CODE SOLUTIONS PLAN REVIEW CHECK SHEET

Permit # B23-0034

Address: 1716 Keller Pkwy. Date: January 29, 2024

Project: Bloomfield Lot 6 Office

SHEET TITLE
WATER PLAN

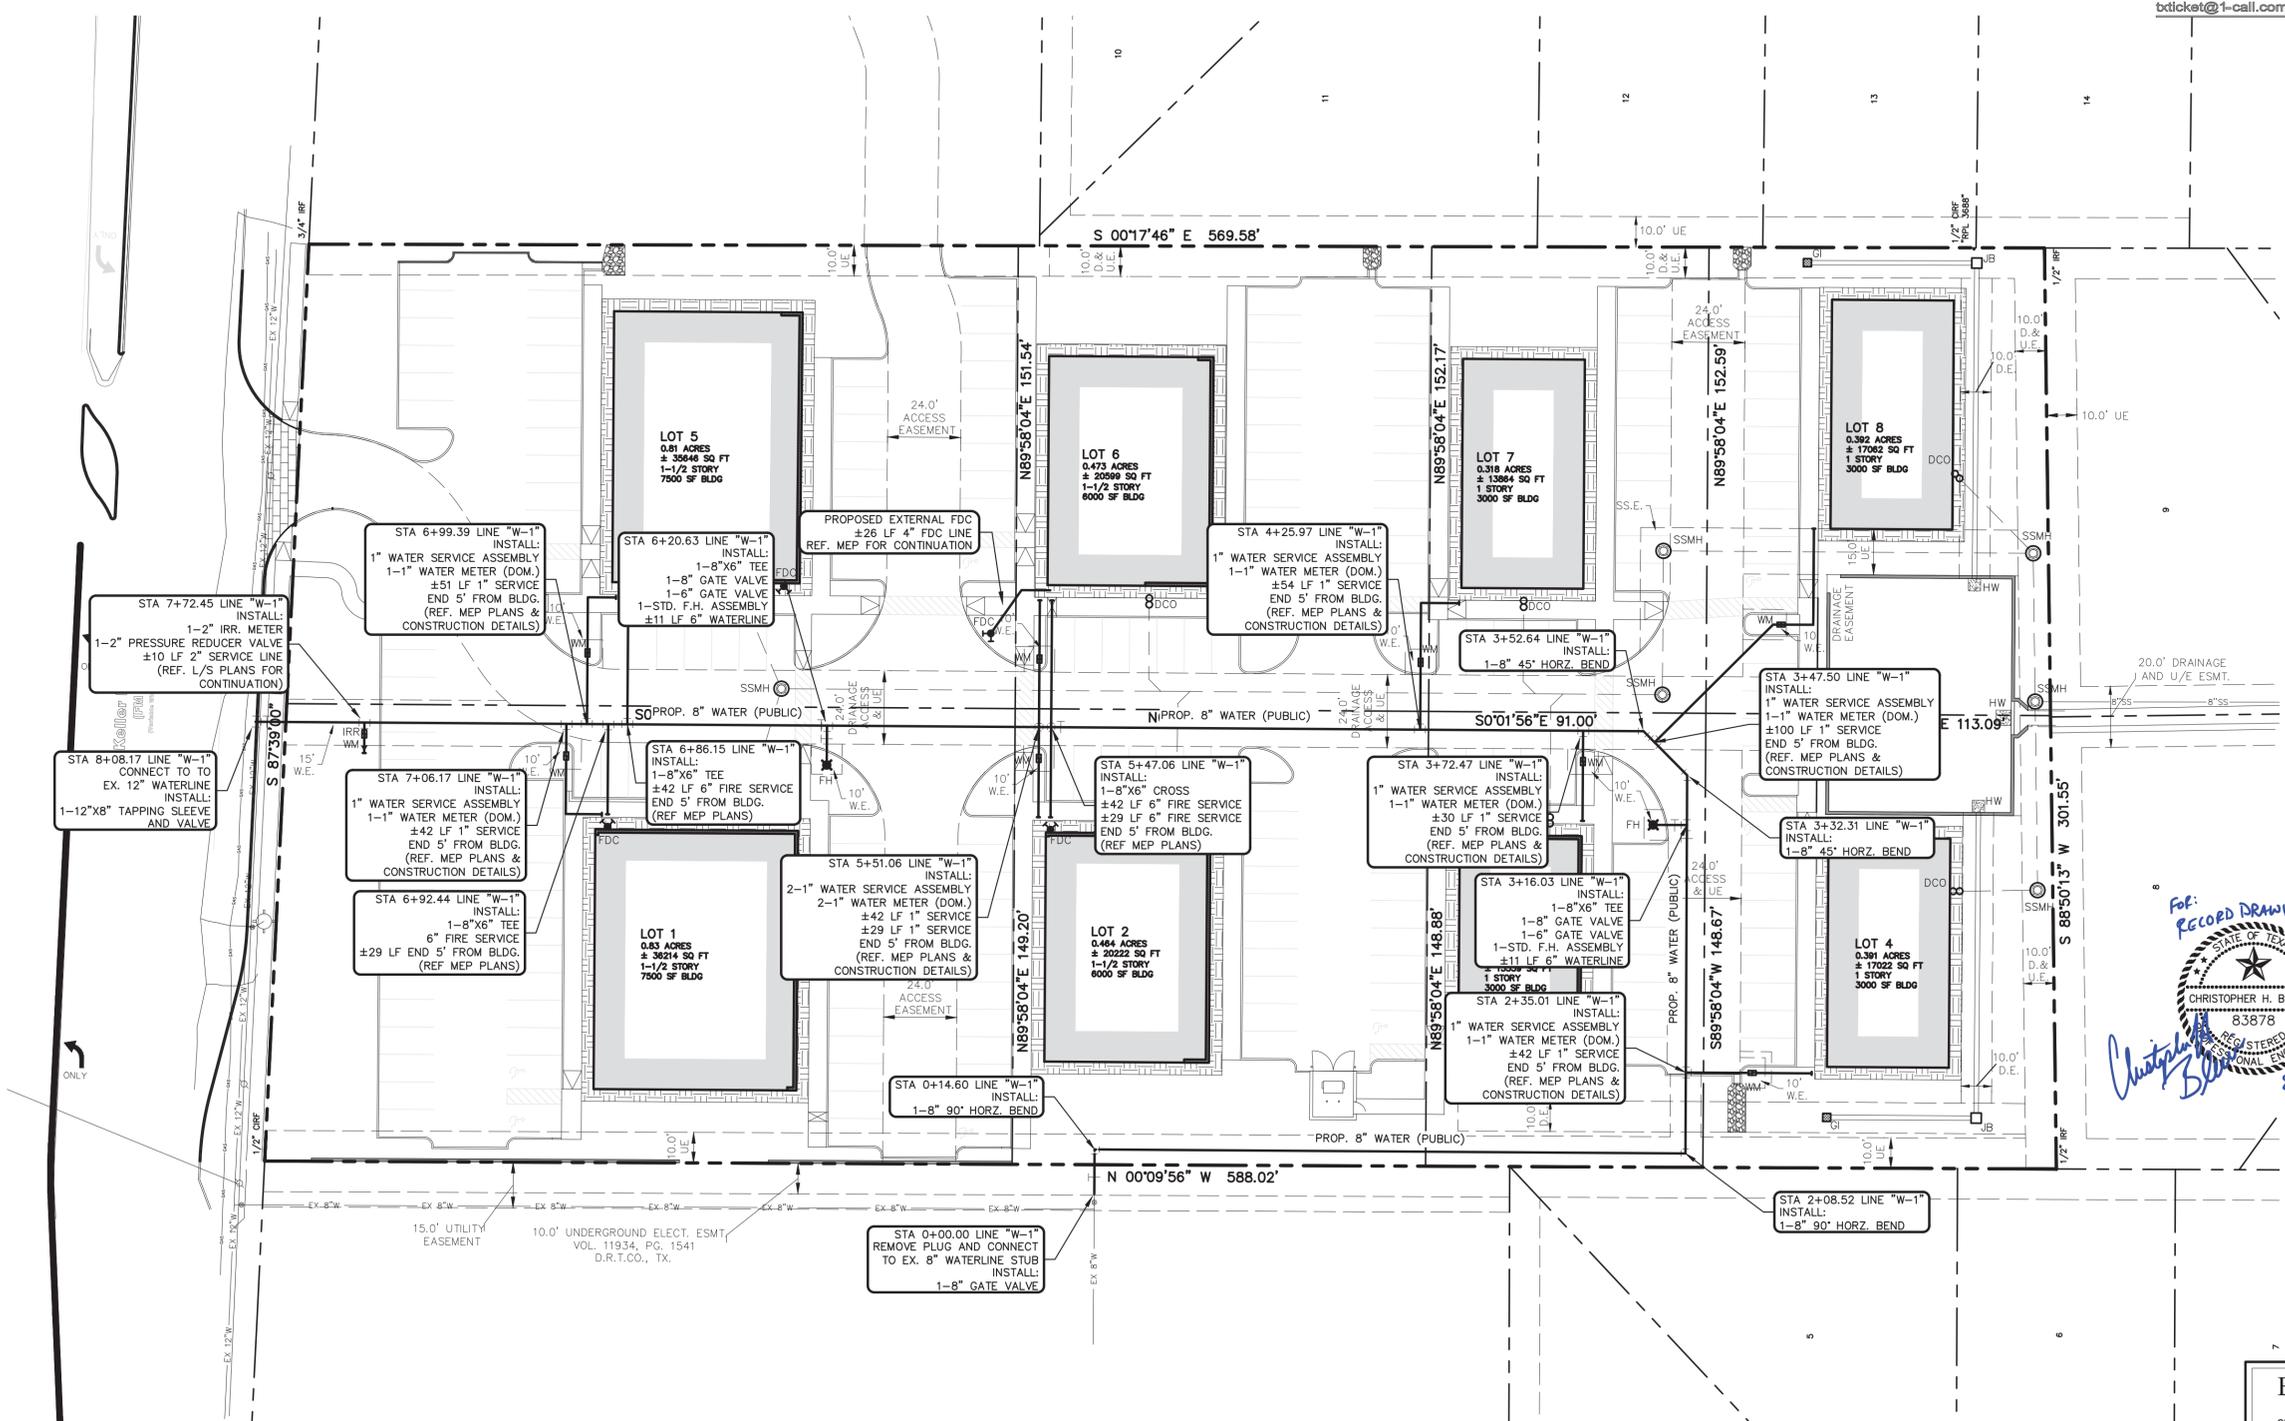
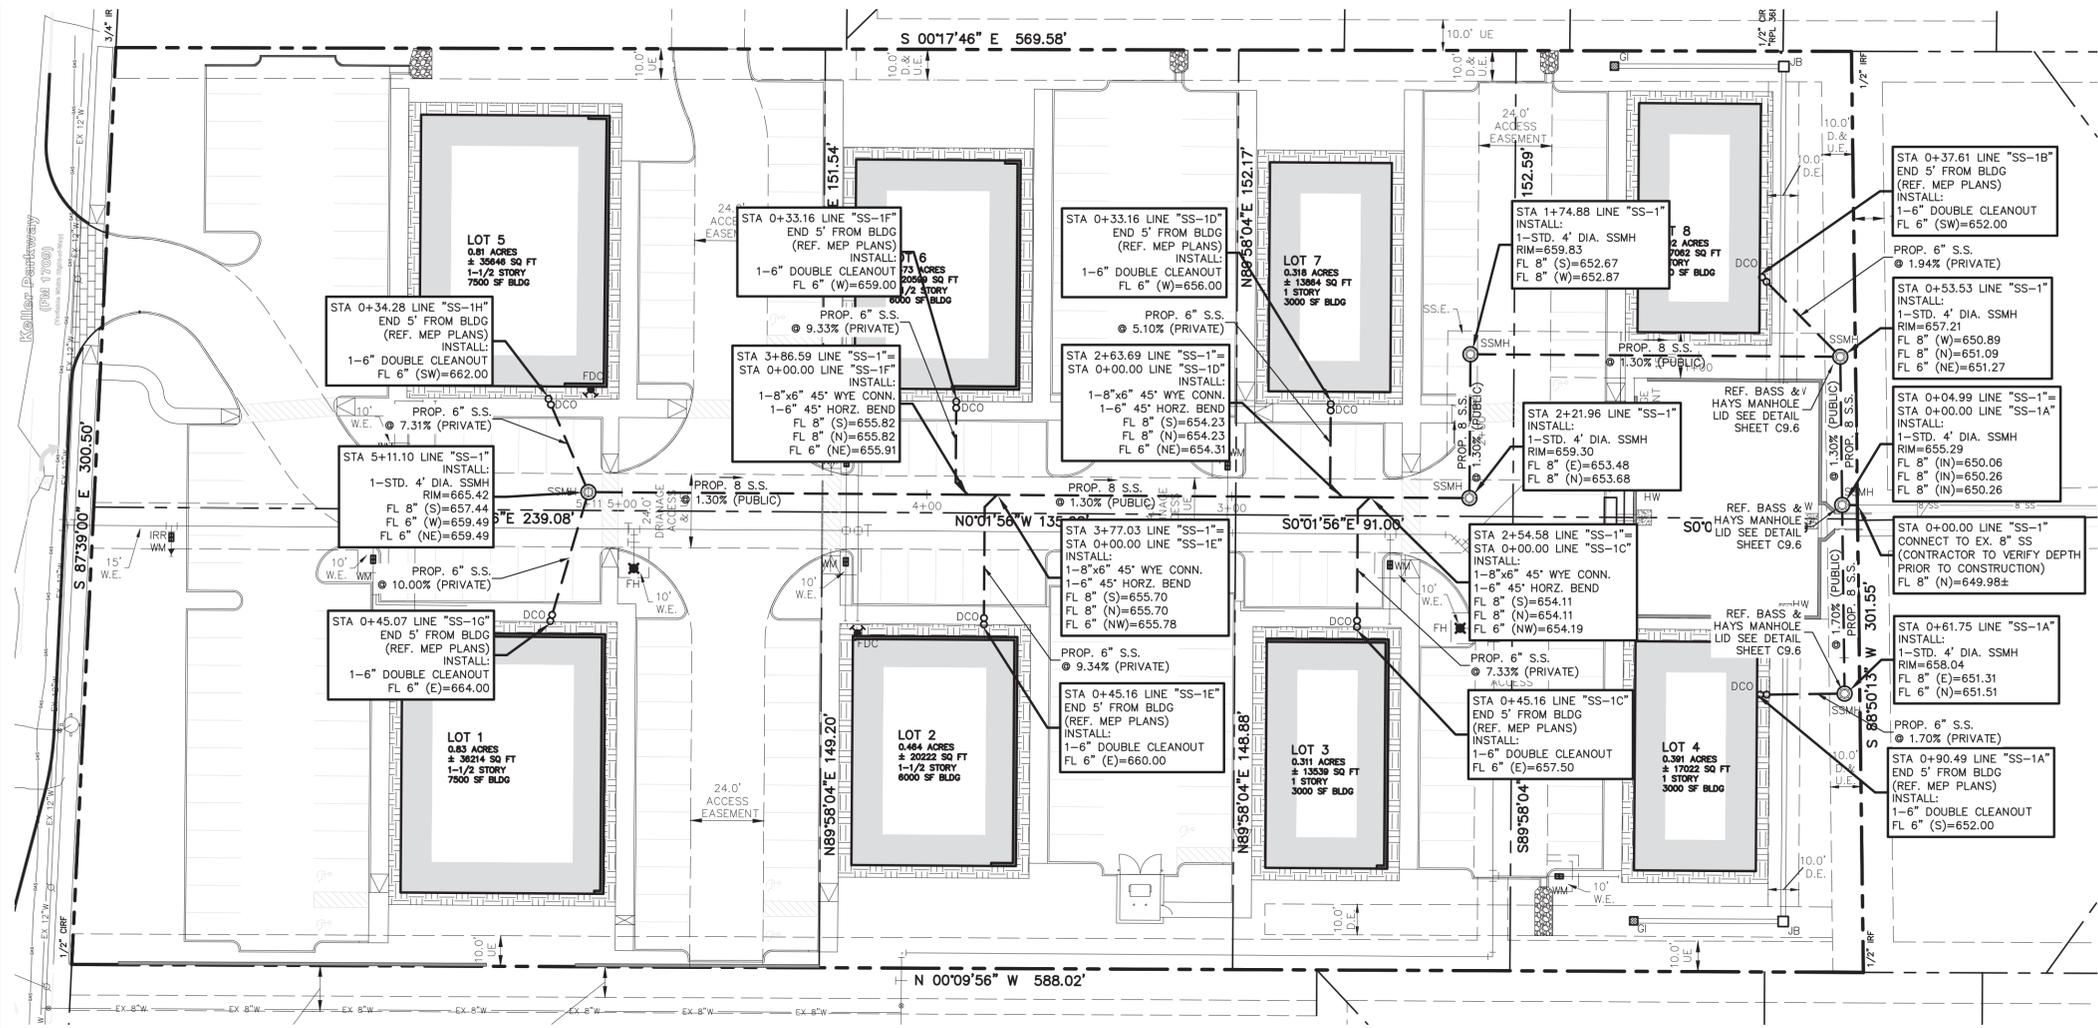
1. Site Utility Plan Not Provided. Please provide site utility plan.

1-4-2024 Please provide utility site plan.

1-29-2024 Resolved

STAIR SECTION

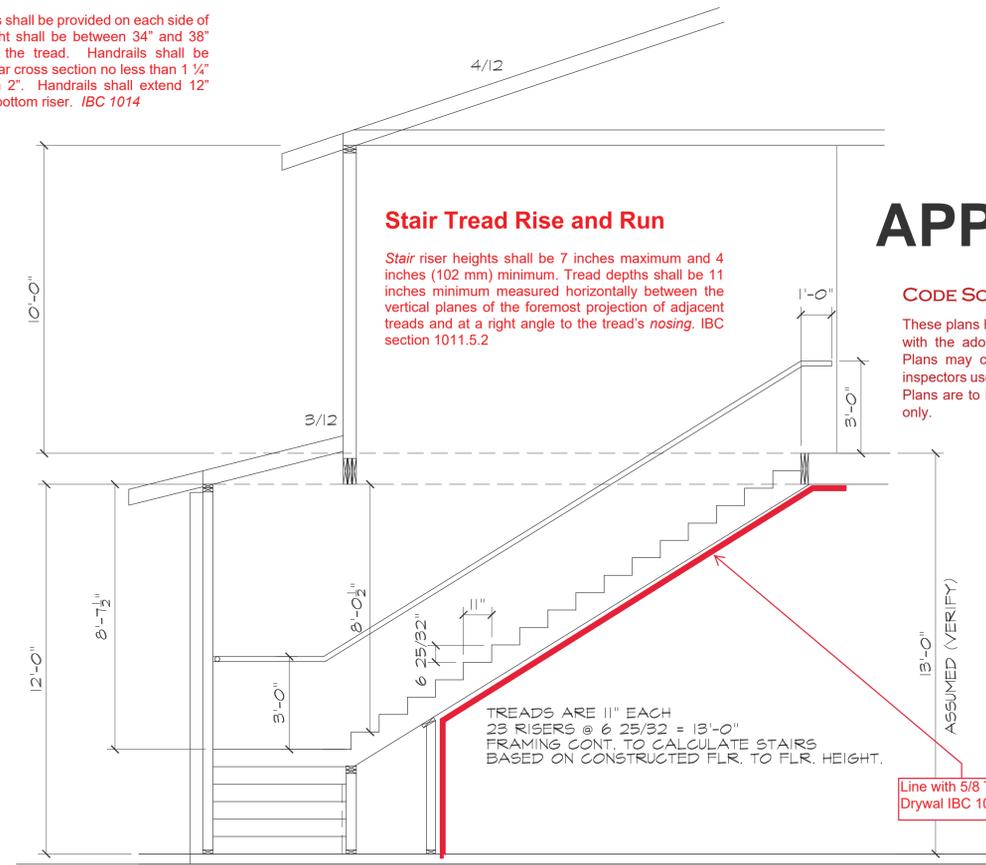
4. Architects plans do not confirm stair tread dimensions. Stair tread rise and run shall be compliant with IBC section 1011.5.2 inserted below:

Please provide revised plans indicating floor depth of the selected floor ceiling assembly (see structural plans) and calculate the rise and run.

5. Handrail height not indicated on plan. Handrails at stairs and ramps shall be located as required by IBC section 1014.2 inserted below:

6. No handrail details provided. Unable to confirm handrail cross section dimensions and graspability. Please provide revised plans including handrail details compliant with IBC section 1014.3 inserted below:

7. No handrail details provided. Unable to confirm handrail extensions at top and bottom of stair runs. Please provide revised plans including handrail details compliant with IBC section 1014.6 inserted below:

8. No handrail details provided. Unable to confirm handrail clearances or projections. Please provide revised plans including handrail details compliant with IBC section 1014.7 & 1014.8 inserted below:

Continuous handrails shall be provided on each side of stair. Handrail height shall be between 34" and 38" above the nose of the tread. Handrails shall be graspable with a circular cross section no less than 1 1/4" and no greater than 2". Handrails shall extend 12" beyond the top and bottom riser. IBC 1014

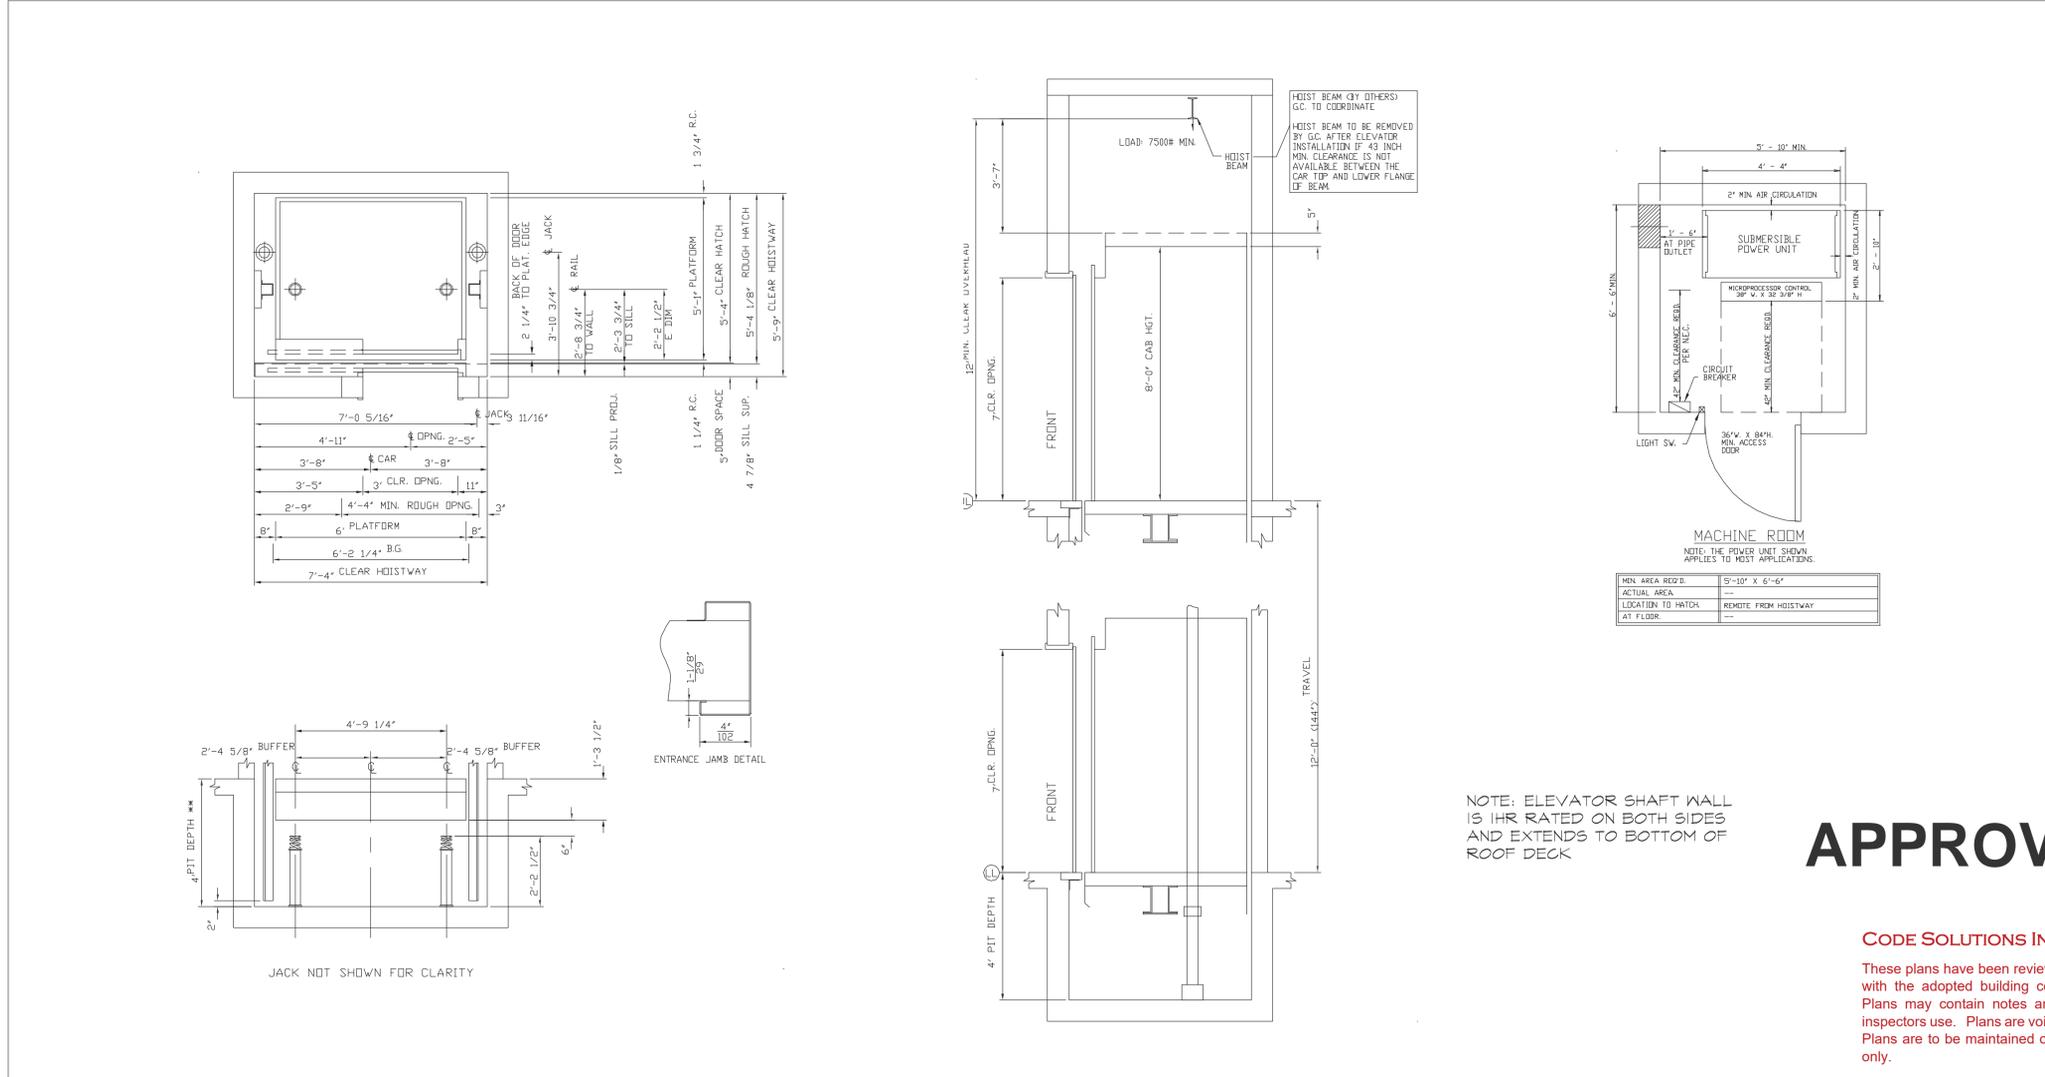
Typical elevator details sheet A9.1 indicates a hydraulic elevator. Please confirm type of elevator and revise sump discharge as needed.
